Rehabilitation of the Existing Community Clinic of Joplin

Addendum #2

Issued 8/4/2016

Attachment A

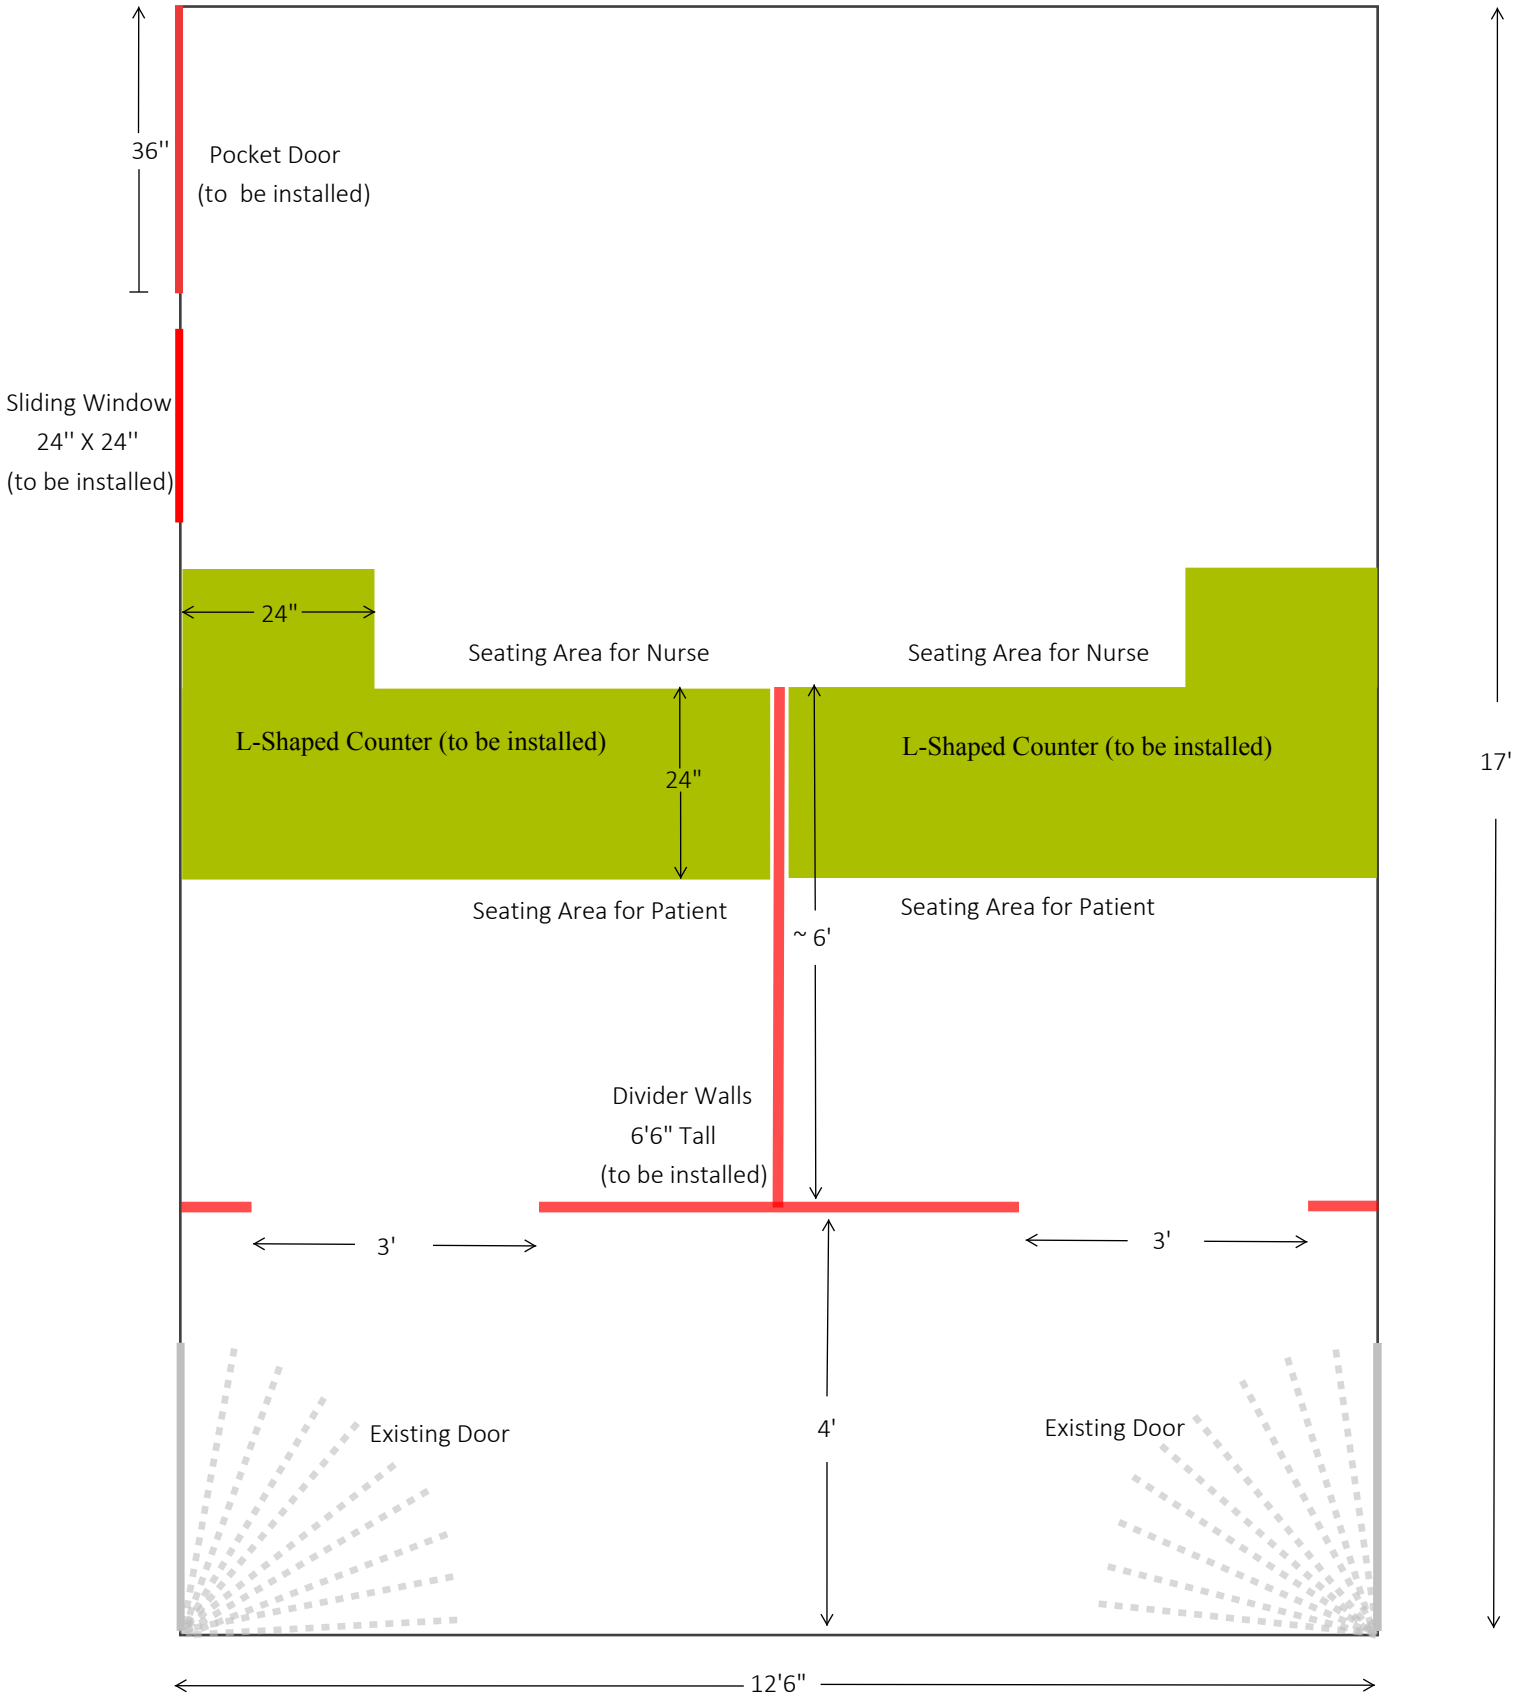
c) Discharge Room Scope Modifications:

i. **Original Specifications:**

~~"Install slider window & 36" stained birch door between discharge office & hallway, close up remaining area & sheetrock"~~

~~"Install (2) 36" pocket doors"~~

ii. Install a 6'6" privacy wall extending up from floor.

iii. Install L-Shaped counters with laminate counter top

Revised Specifications:

Install a 24" x 24" slider window & a 36" pocket door between discharge office and hallway, close up remaining area & sheetrock.
